**Re: Response to Comments on Little Rock Updated
Closeout Plan, Revision 20-1 to Permit No. GR007RE**

Freeport-McMoRan Tyrone Inc. (Tyrone) submitted an update to the Little Rock Closure/Closeout Plan (CCP) on June 20, 2020. The application was deemed administratively complete on July 6, 2020 by the Mining and Minerals Division (MMD). In a letter dated November 3, 2020, MMD provided comments and forwarded comments from the other agencies and the public to Tyrone. This letter is in response to the comment letters.

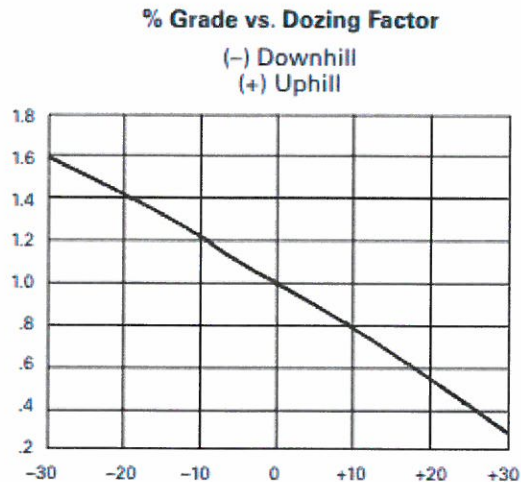
32. *Appendix A, Sheet 13, Reclamation Haul Roads, of the Updated CCP, show, in part, the proposed reclamation haul routes for the Little Rock Mine. Please indicate the roads or other routes that will be maintained by Tyrone for post-closeout monitoring and maintenance.*

In Appendix A, Sheet 12 shows portions of the Little Rock Haul Road, Northern Haul Road, and Southern Haul Road being used for maintenance activities (areas that are not revegetated).
